AIRWORTHINESS DIRECTIVE

Piper PA-28 Series Aeroplanes

**AD/PA-28/91
Amdt 1**

Main Landing Gear Side Brace Stud

Figure 1

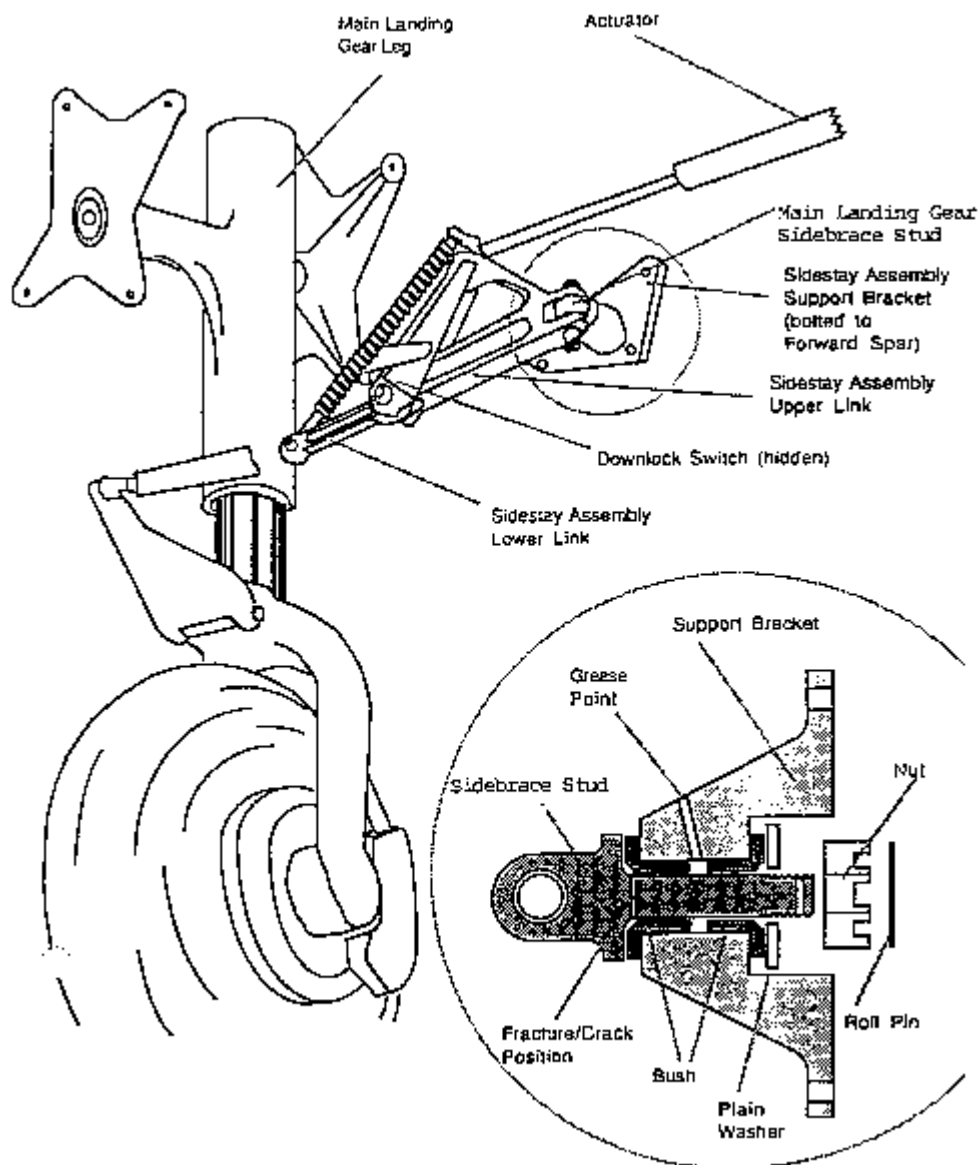
Requirement: Remove both the left and right main gear side brace studs from the aircraft in accordance with the instructions contained in the Landing Gear section of the maintenance manual, and inspect each main gear side brace stud for cracks using fluorescent penetrant or magnetic particle inspection methods. Figure 1 of this Directive depicts the area where the sidebrace stud is to be inspected.

This figure is provided to depict the area of the sidebrace stud to be inspected. This is not intended to represent the configuration of all models affected.

For any main gear side brace stud found cracked, replace the cracked stud with an approved serviceable part in accordance with the instructions contained in the Landing Gear section of the applicable maintenance manual.

For the affected Models PA28R-180, -200, -201, and -201T aircraft, the part number 95299-00 or 95299-02 main gear side brace studs are no longer manufactured. A new main gear side brace stud bracket assembly, part number(s) 95643-06, 95643-07, 95643-08, or 95643-09, as applicable, must be installed if cracks are found as a result of the required inspection. No repetitive inspection will be required for these affected aircraft models when this bracket assembly is installed;

For the affected Model PA-28R-180, PA-28R-200, PA-28R-201, and PA-28R-201T aircraft, ream the existing two-piece bushings to an inside diameter of 0.624 inch to 0.625 inch, chamfer the head side of the bushing to accommodate the radius in the shank of the main gear side brace stud, and install the 5/8 inch stud, P/N 78717-02. No repetitive inspections will be required by this Airworthiness Directive when this action is accomplished on both the left and right bracket assemblies. If the bushings cannot be reamed while installed in the bracket (i.e., the bushings are loose), then install a main gear side brace bracket assembly, P/N 95643-06, P/N 95643-07, P/N 95643-08, or P/N 95643-09, as applicable. Models PA-28R-180 with serial numbers 28R-30004 through 28R-31270 and PA-28R-200 with serial numbers 28R-35001 through 28R-35820 and 28R-7135001 through 28R-7135062, may be equipped with a bracket casting identified with casting number 67073-2 or 67073-3 and may require the following modification to P/N 78717-02 for proper installation:

- a. Reduce the length of the stud to 1.688 ± 0.15 inches;
- b. Add additional rolled threads to 1.125 ± 0.015 inches from the flange. Note that the stud is heat treated to 180 to 200 ksi; and
- c. Drill an additional roll pin hole 90 degrees to the existing hole, and approximately 1.480 inches from the flange.
